To all Customers using Molex
connectors 98193-0001 & 98193-0010

Molex MOX Receptacle Housing 6 circuit Single Row
Manufacturing and Design Improvements
Customer Notification

Figure 1: Current Production

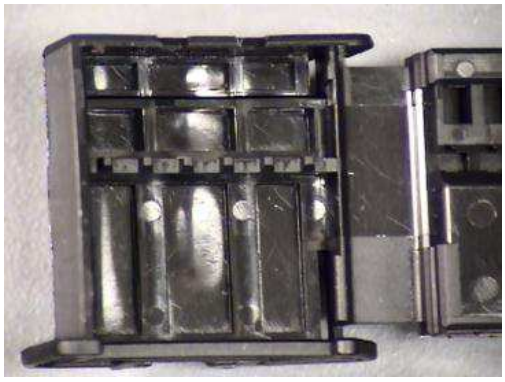
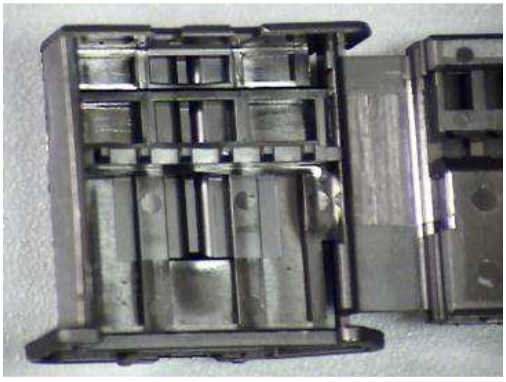
The change consists of adding core-outs which will help maintain a more uniform part thickness. The sink marks are as shown in Figure 1 below. These core-outs and reduction of sink marks are as shown in Figure 2. This change will have no effect on form, fit, or function.
